RE 820 Civic Center Drive, Clara- Review of Changes to Approved

Plans- Garage/carport and bathroom addition,

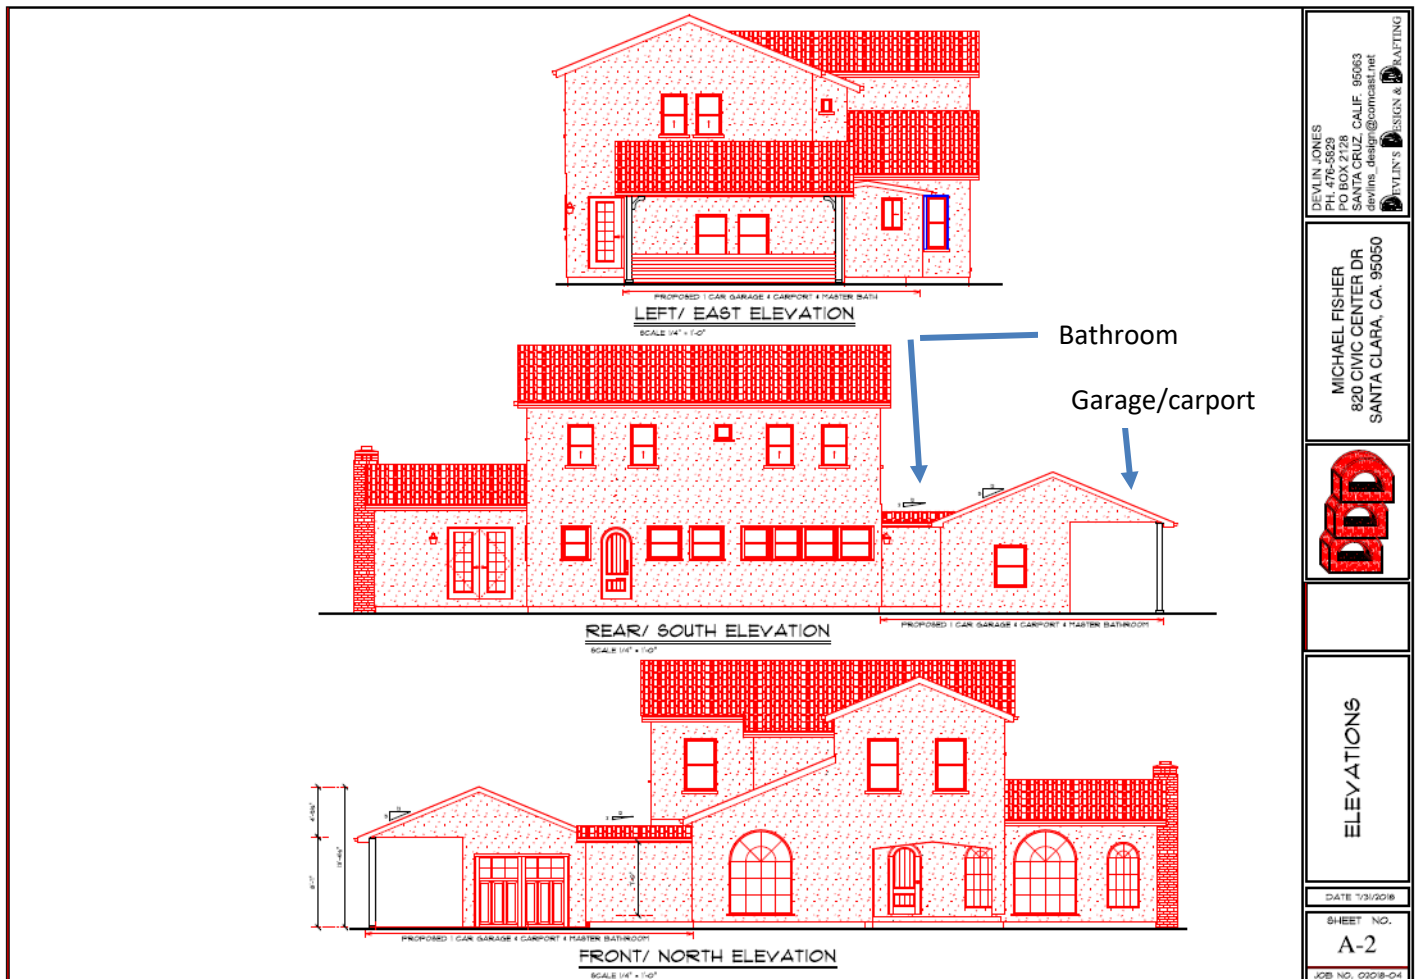
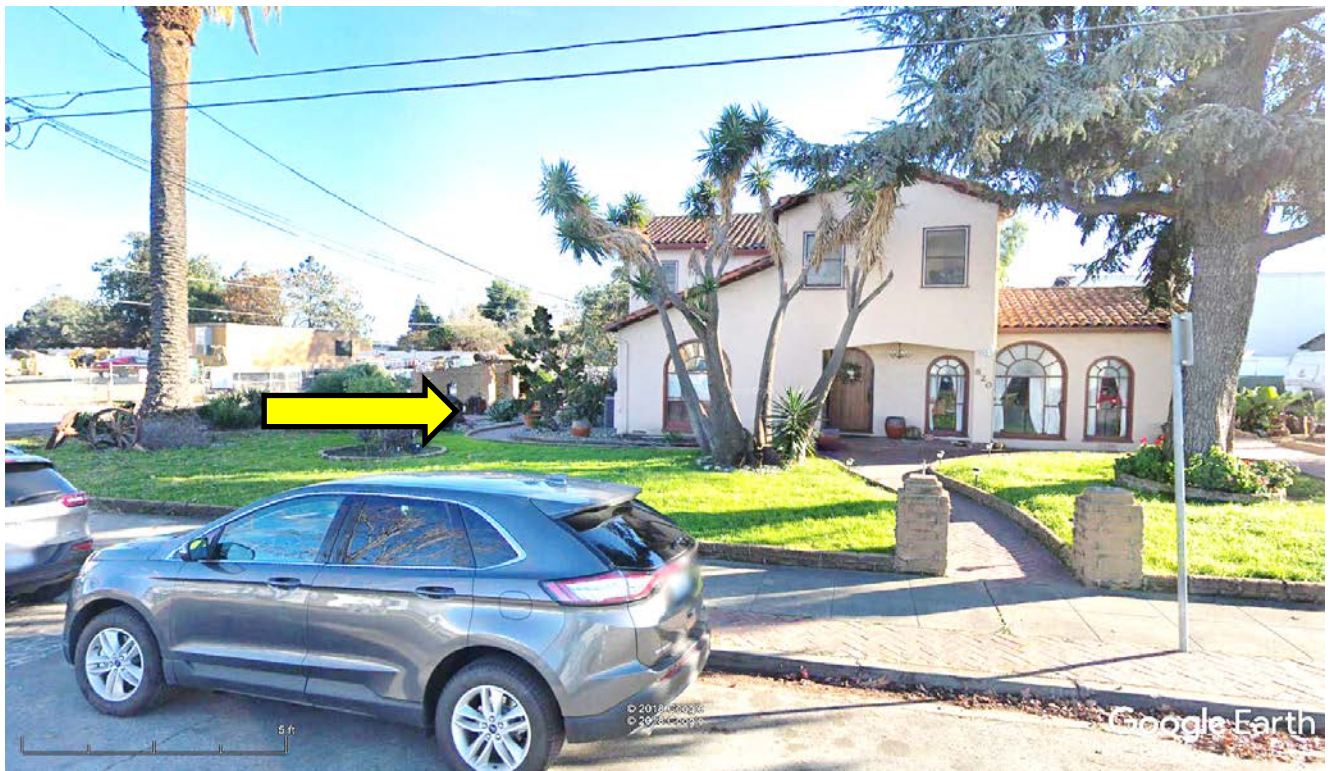
East Façade Changes are proposed for the east side façade- a secondary façade. However, the new garage building and addition will be seen from the front of the property as well as the side. Therefore, the addition and new garage must be considered for the change they make to the views of the front facade. The 100 sq. ft. addition is also considered for its impact to the historic building and its structure.

Figure 2 : Sheet of elevations showing the proposed bathroom addition and the new garage and carport. From the side the garage will screen the lower portion of the house. From the rear, the house is not visible and the new garage/carport will be only slightly visible from Alviso St. From the front the garage/carport is seen set back from the house as a separate structure. The bathroom set back from the front façade of the historic house and is attached to the historic house. This is a minor addition, on a secondary façade and will be covered with plain stucco and roof tiles that are similar to the historic building. The small addition is designed to be compatible with the front view of the historic house.
